Digital View Product Revision

To: All Digital View Partners and Customers
 From: Steve Simons, Channel Manager
 Date: 12/19/2008
 Re: Product Revision Notice – SVH-1920 / 416960050-3

Digital View announces a product revision for the LCD Controller model SVH-1920. The redesigned SVH-1920 is due to the announced discontinuation of the buffer memory module, and the addition of color matching functionality:

SVH-1920(General) Product Revision Details

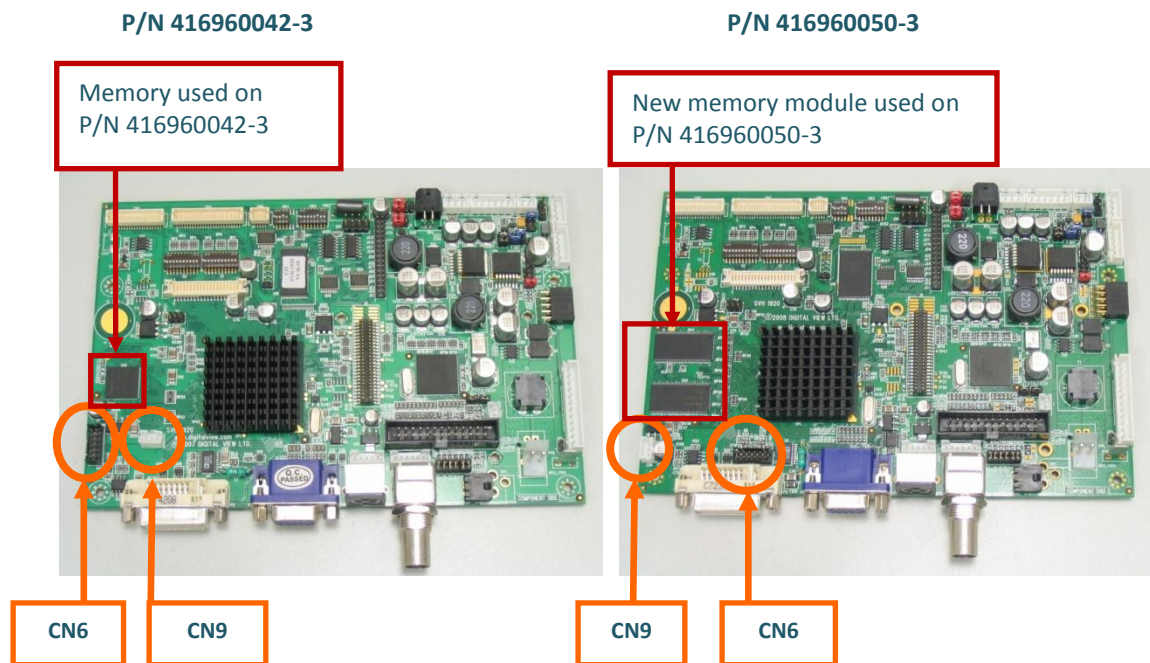
In response to an anticipated component supply issue, Digital View has changed the PCB board to accommodate different buffer memory:

- 1) Change CN6 connector (Aux component input connector- *Reserved*) position.
- 2) Change CN9 connector (Ambient light sensor connector) position.
- 3) Add memory position for Color Management Application (Call DV for details).
